**NEW YORK STATE THRUWAY AUTHORITY
DEPARTMENT OF ENGINEERING**

**ALBANY, NY
FEBRUARY 8, 2024**

**AMENDMENT NO. 1
TO**

**CONTRACT TANY 24-8
D214964
2" MILL AND INLAY, SAFETY
IMPROVEMENTS AND MISCELLANEOUS WORK
BETWEEN MILEPOST 47.6+/- AND MILEPOST 60.1+/-
IN THE NEW YORK DIVISION
OF THE NEW YORK STATE THRUWAY
IN ORANGE COUNTY**

TITLE OF PROJECT PAVEMENT RESURFACING AND SAFETY IMPROVEMENT	CONTRACT NUMBER: TANY 24-8
LOCATION OF PROJECT NY DIVISION MP 48.0 TO 60.1	DATE: 1/2024
TITLE OF DRAWING GENERAL PLAN	DRAWING NUMBER: GP-35

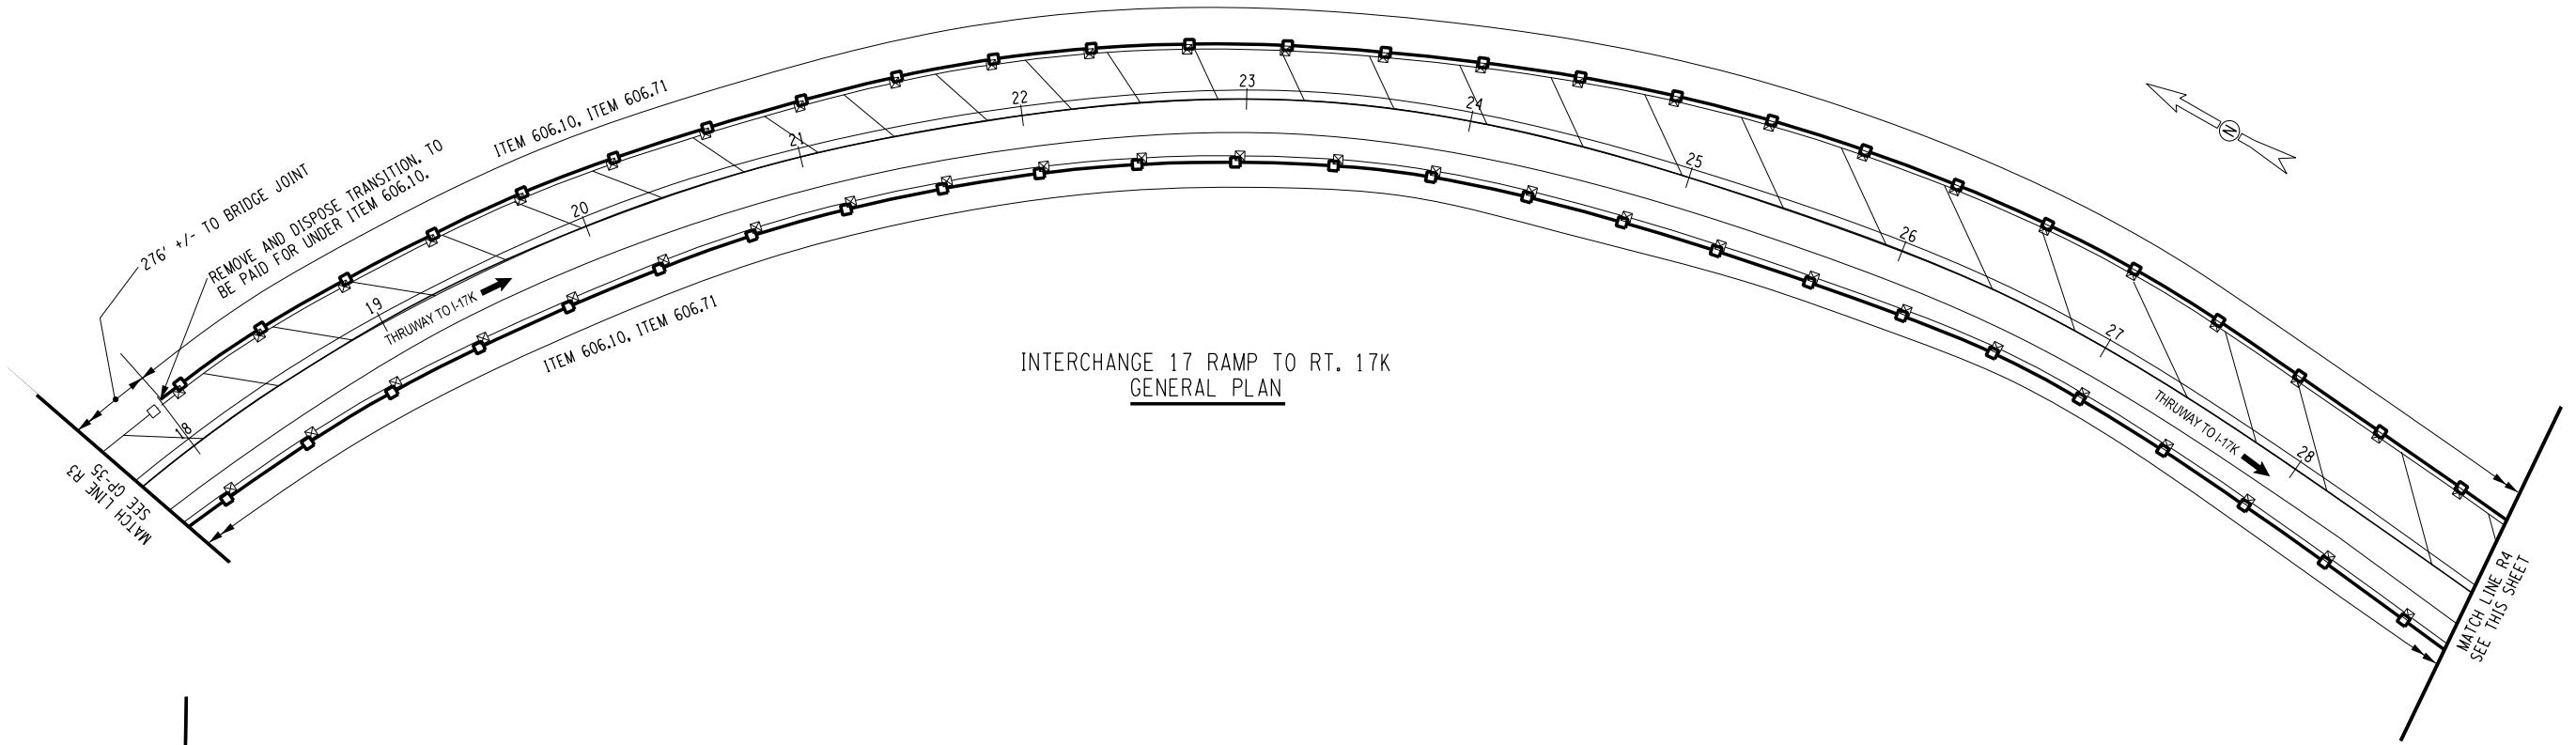
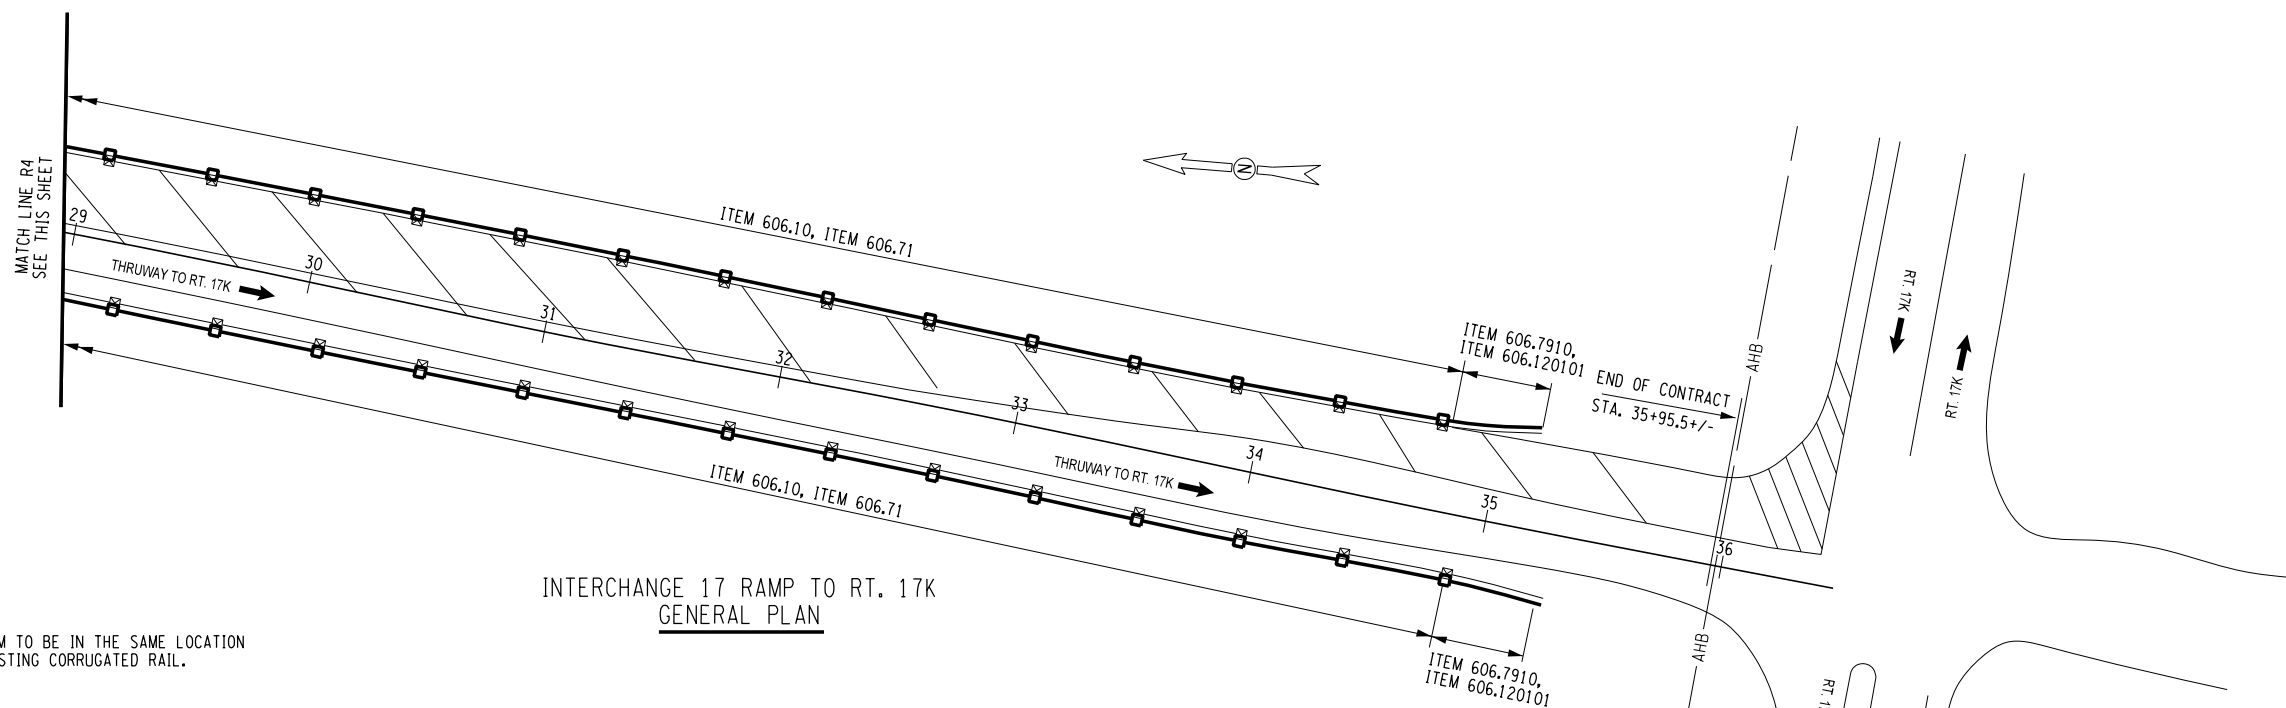
37. **DELETE** Drawing Number GP-34, Sheet 105 of 108, and **SUBSTITUTE** with the attached Drawing Number GP-34, Sheet 105-A1 of 108. The Exit 17 D-Ramp right side rail has been updated to be shown as proposed and added existing left rail from Sta. 15+00 to matchline R3. Extended proposed right side box beam guide rail from Rte. 300 bridge to matchline R3.

TITLE OF DRAWING: GENERAL PLAN

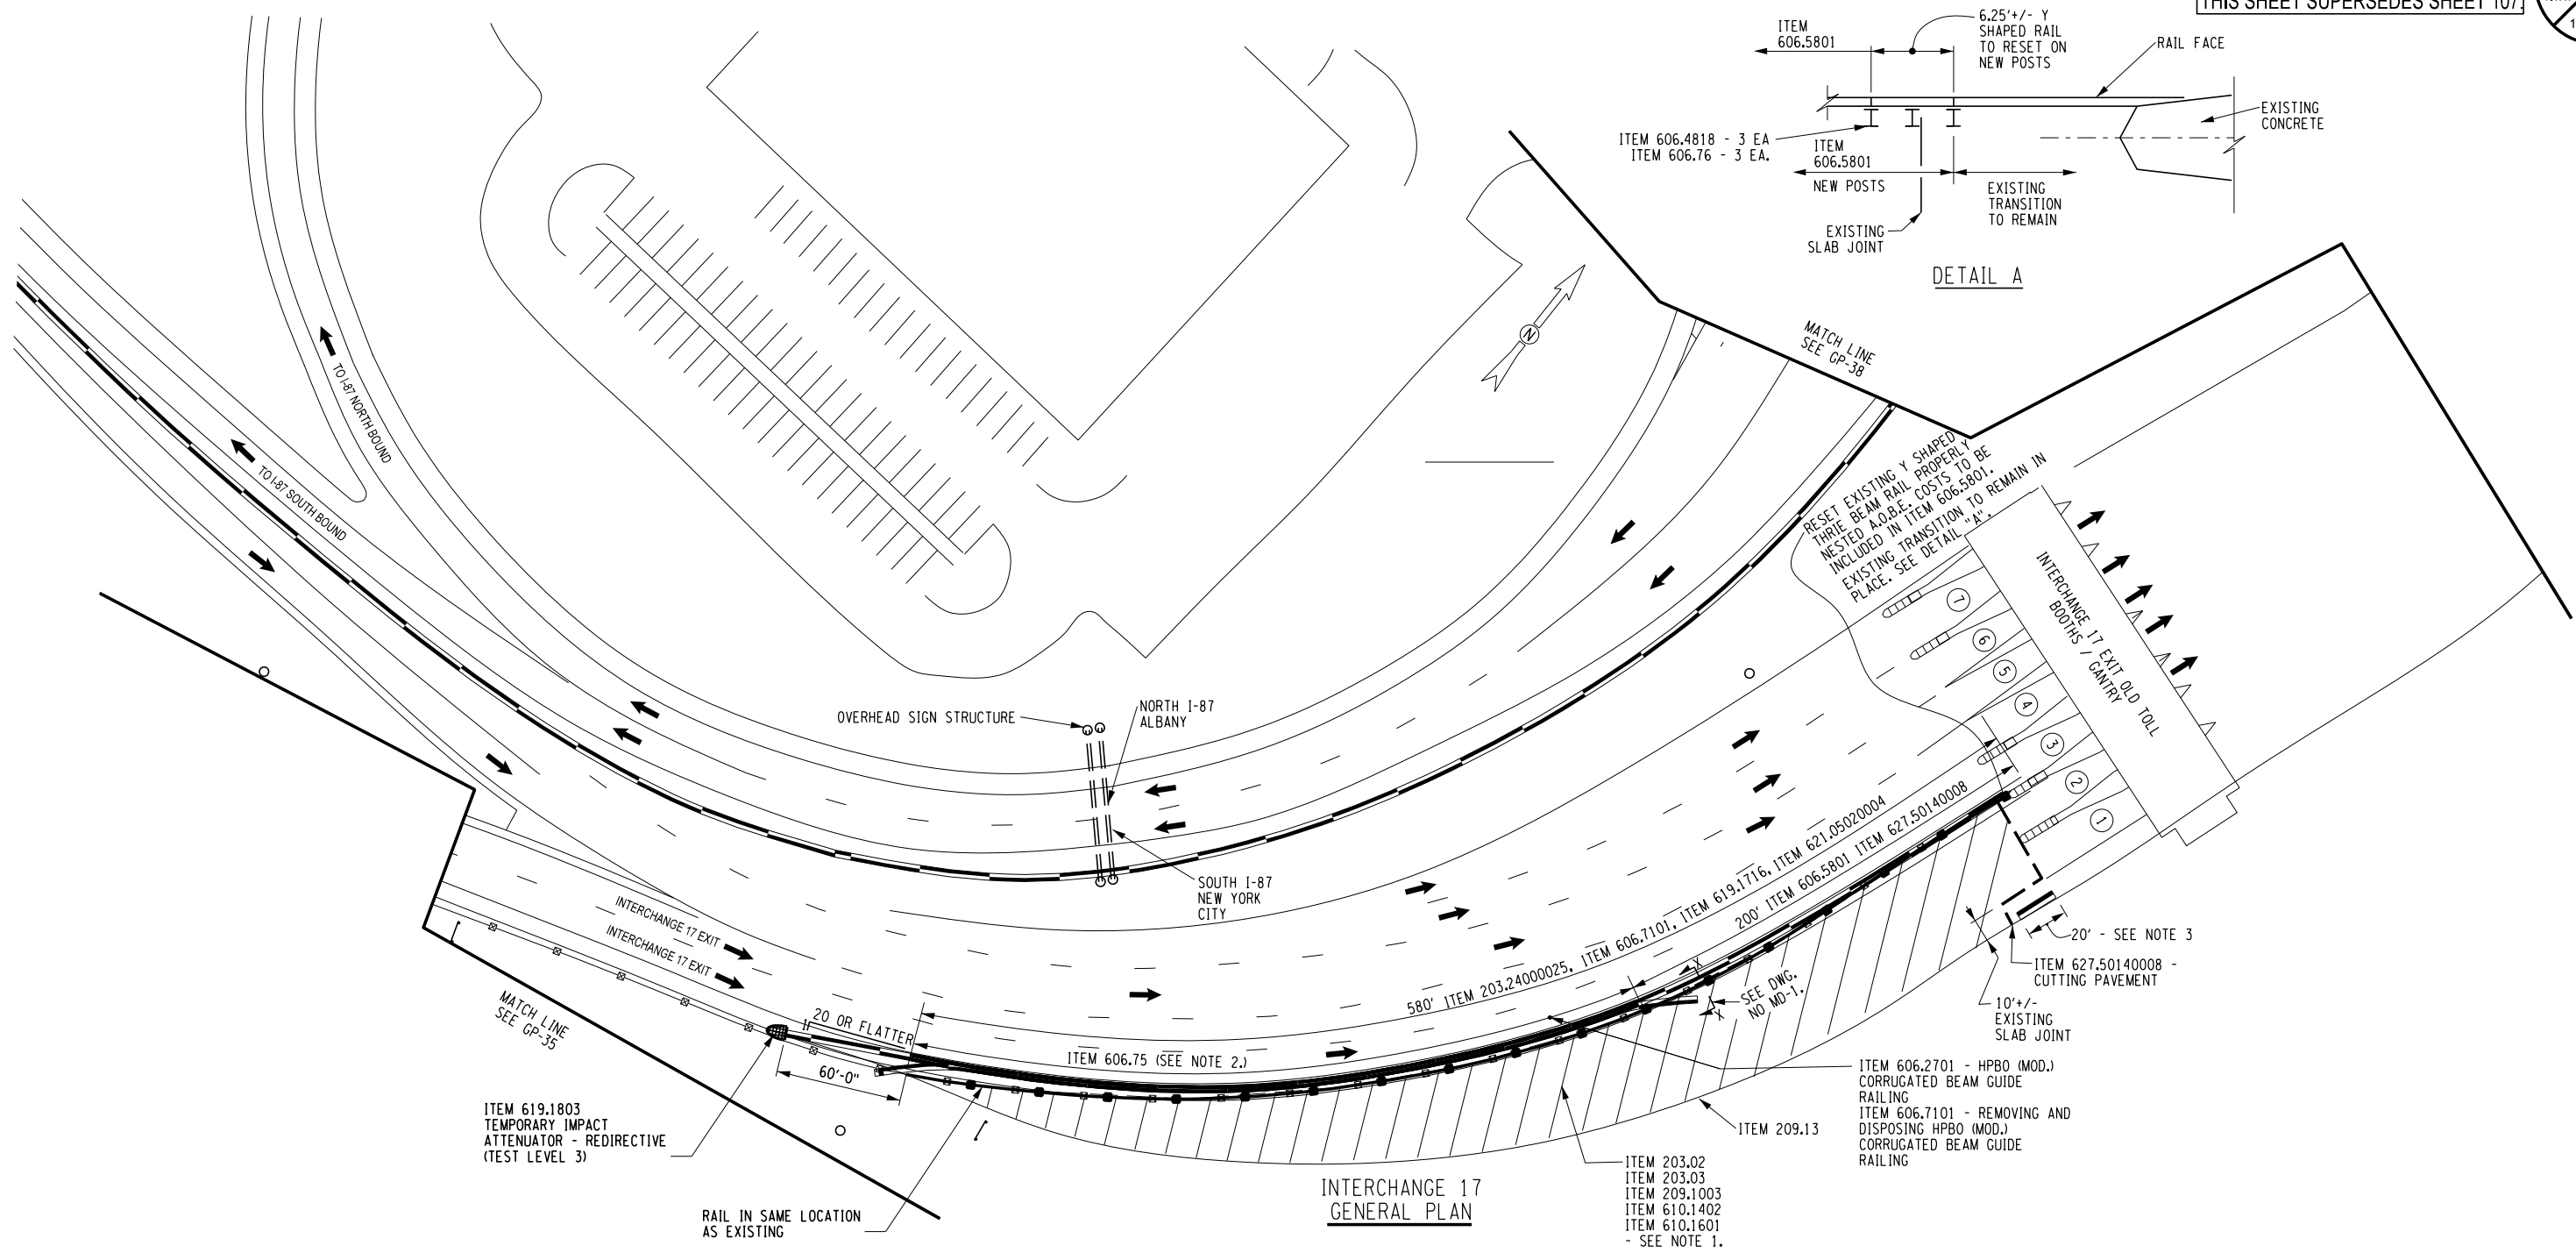
38. **DELETE** Drawing Number GP-35, Sheet 106 of 108, and **SUBSTITUTE** with the attached Drawing Number GP-35, Sheet 106-A1 of 108. Added Note 1. Added existing left side box beam guide rail from matchline R3 to Sta. 18+00. Added at Sta. 18+00 left side note: “Remove and dispose transition...”.

1. REMOVE AND DISPOSE OF 10" THICK REINFORCED CONCRETE SLABS. COSTS TO BE INCLUDED IN ITEM 203.02 UNCLASSIFIED EXCAVATION AND DISPOSAL. INSTALL EMBANKMENT IN PLACE AND TOPSOIL. GRADE TO DRAIN. INSTALL SEEDING AND ESTABLISH TURF.
2. REMOVE EXISTING TEMPORARY CONCRETE BARRIER A.O.B.E. AFTER NEW HPBO (MOD.) CORRUGATED BEAM GUIDE RAILING IS INSTALLED.
3. CONCRETE BARRIER AND BOX BEAM GUIDE RAIL TO REMAIN IN PLACE.
